Oconee Nuclear Station

Subject: Oconee Nuclear Station
Docket Nos. 50-269
Request for Additional Information Concerning
Reactor Pressure Vessel Beltline Region Cross-
Sectional Developed Inner-Surface Areas of Plate
and Welds for Oconee Nuclear Station Unit 1

Reactor Pressure Vessel Beltline Region Cross-
Sectional Developed Inner-Surface Areas of Plate
and Welds for Oconee Nuclear Station Unit 1

Markup of Pressurized Thermal Shock Summary
Report for Oconee Nuclear Station Unit 1

Figure 3.2-2. Reactor Vessel Weldment Locations in Oconee Unit 1

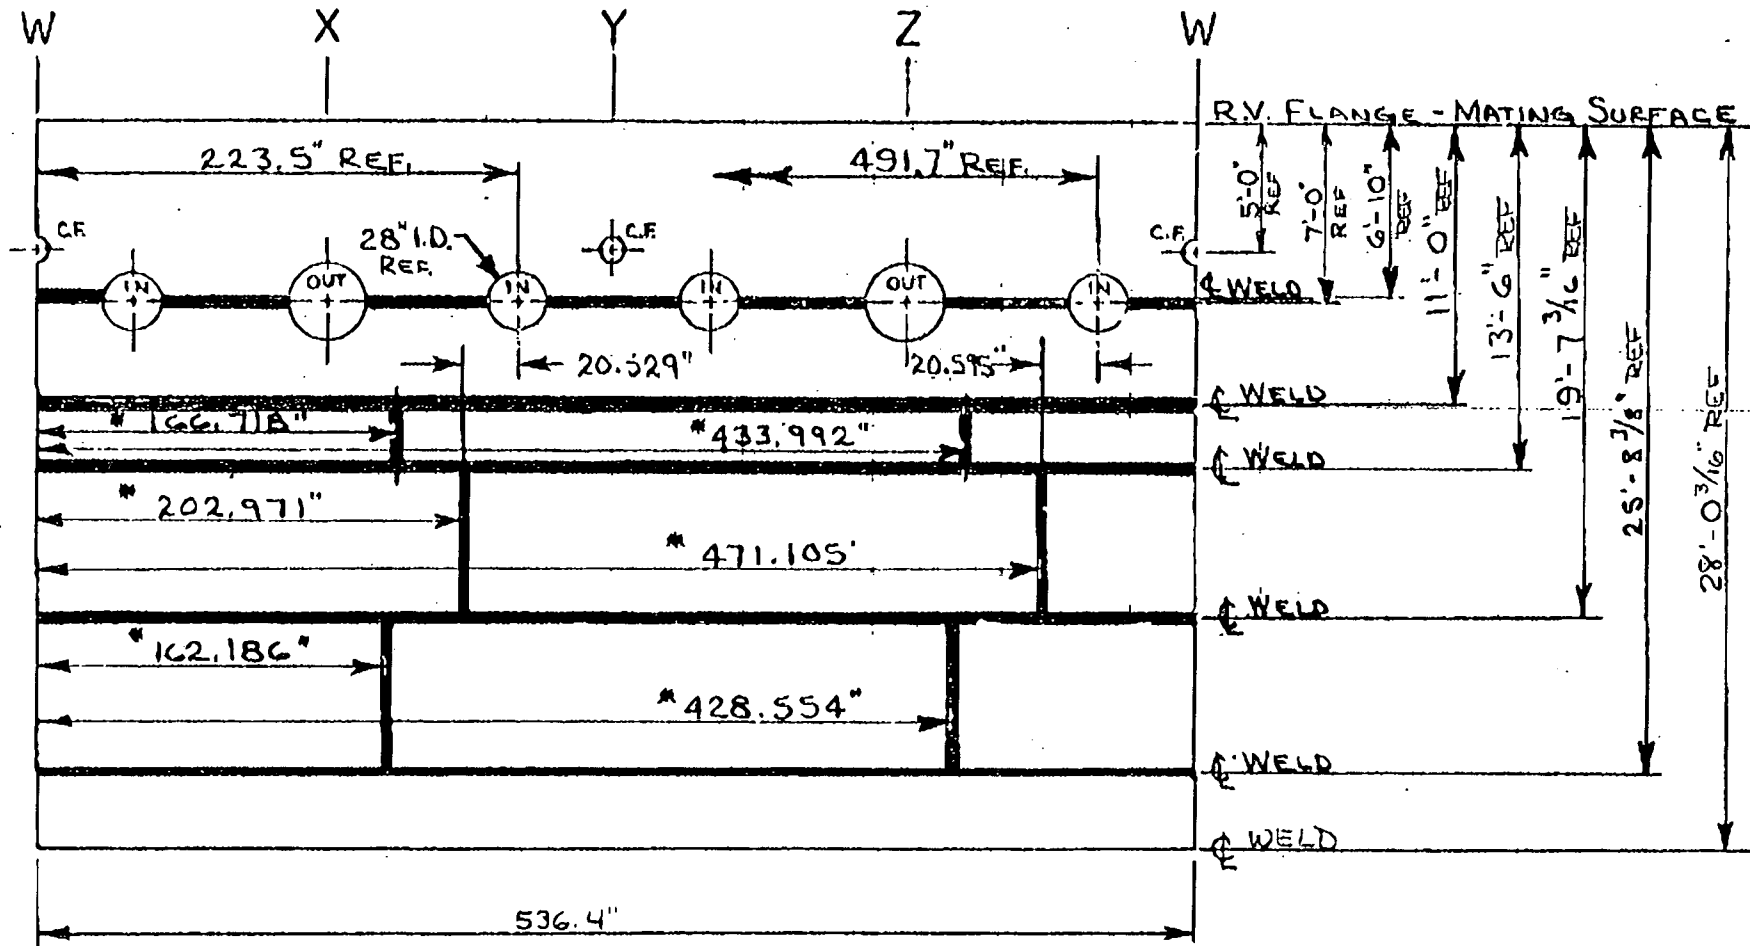
In a letter dated March 23, 1998, the NRC issued a request for information concerning the reactor pressure vessel beltline region cross-sectional developed inner-surface areas of plate and welds for Oconee Nuclear Station Unit 1. The information was needed to perform an overall pressurized thermal shock analysis and revise Regulatory Guide 1.154. Attachment 1 to this letter provides the additional information that was requested by the NRC.

Dimensions based on inside travel
